Allied Engineering Assoc., Inc.

Our Job # 1127

RE: #62 Rocky Lane Engineering Review

PROPOSED OVERALL SITE PLAN

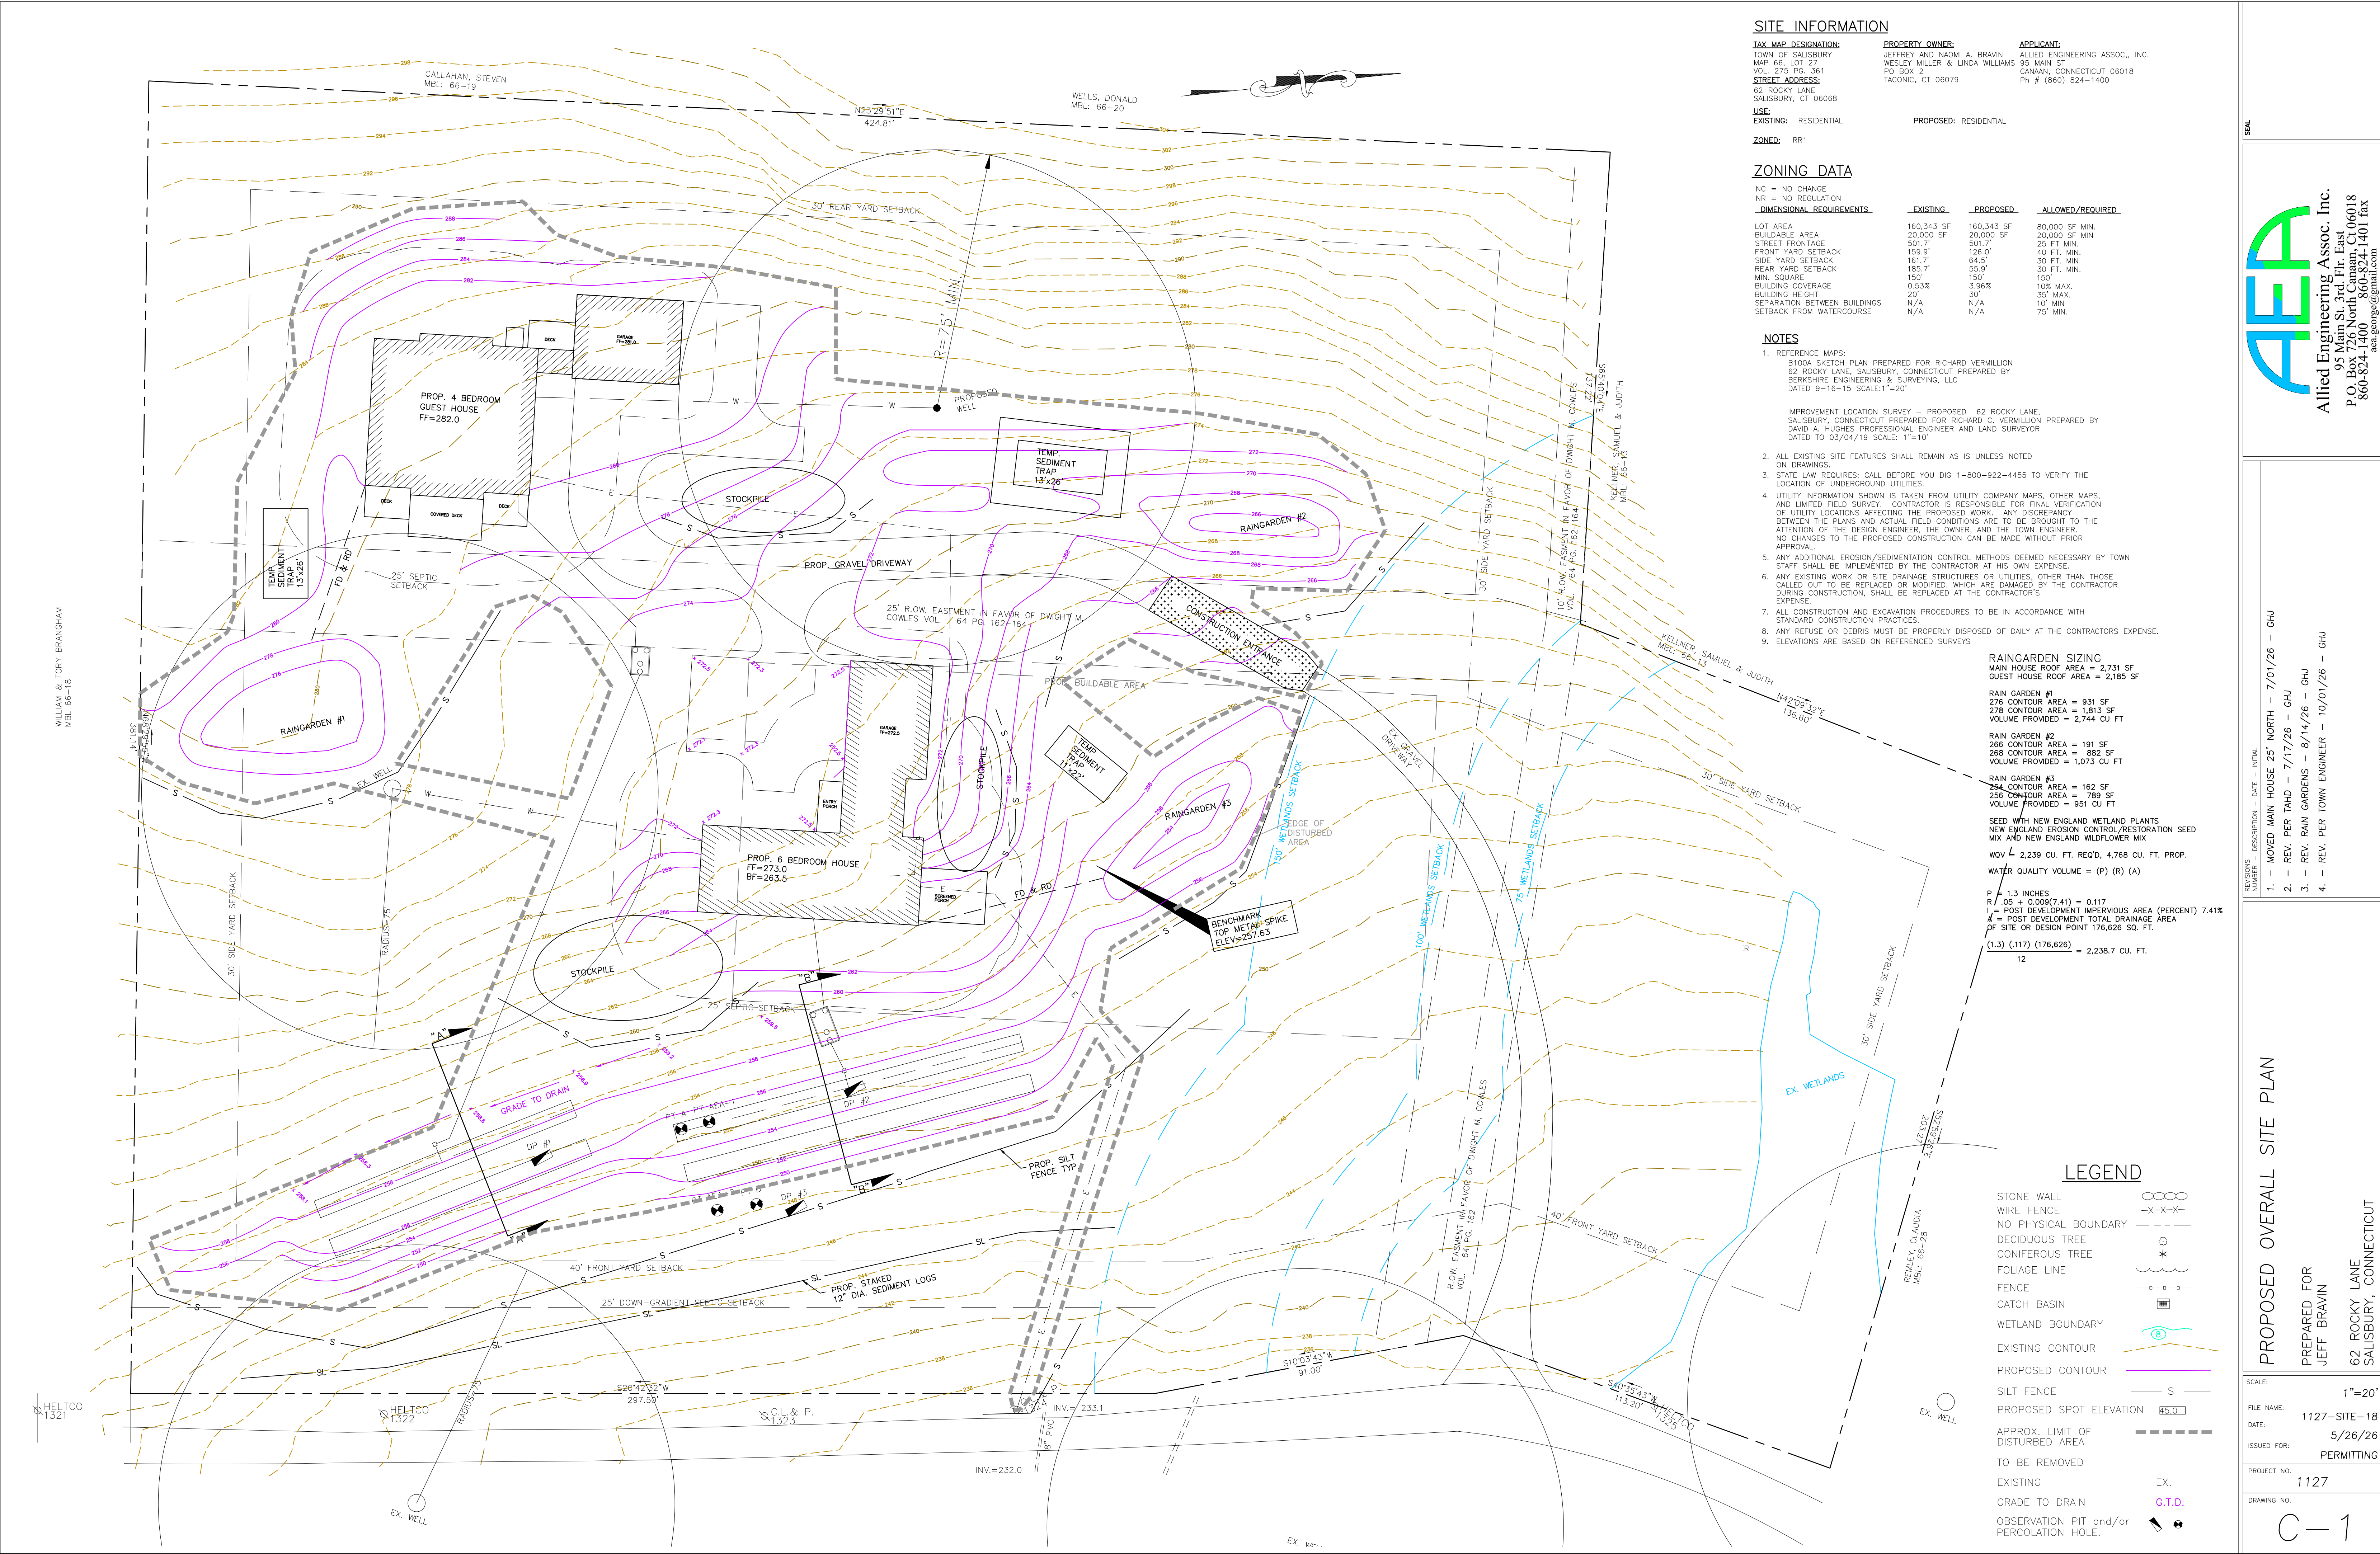
1. The Street name has been added to the plan.
2. Temporary Sediment Traps have been added to the plan.
3. All disturbed finished grade slopes have been shown with Erosion Control Blankets.
4. Staked Haybales have been replaced with 12" dia. Sediment logs.
5. Stockpile areas have been added to the plan.
6. The approved Septic Plan had a rain garden adjacent to the well.
7. A 24 hour contact number has been added to the plan.
8. A Construction Entrance has been added to the plan.
9. Spot elevations have been added to clarify the grading.
10. Spot elevations have been added to the plan.
11. A Demolition Plan has been added to the set.
12. The regrading of the existing driveway to have a cross slope will be done during maintenance after construction.
13. An Erosion and Sedimentation Control estimate has been provided.

PREVIOUS DESCRIPTION - DATE - INITIAL
1. - MOVED MAIN HOUSE 25' NORTH - 7/01/26 - GHJ
2. - REV. PER TAHD - 7/17/26 - GHJ
3. - REV. RAIN GARDENS - 8/14/26 - GHJ
4. - REV. PER TOWN ENGINEER - 10/01/26 - GHJ
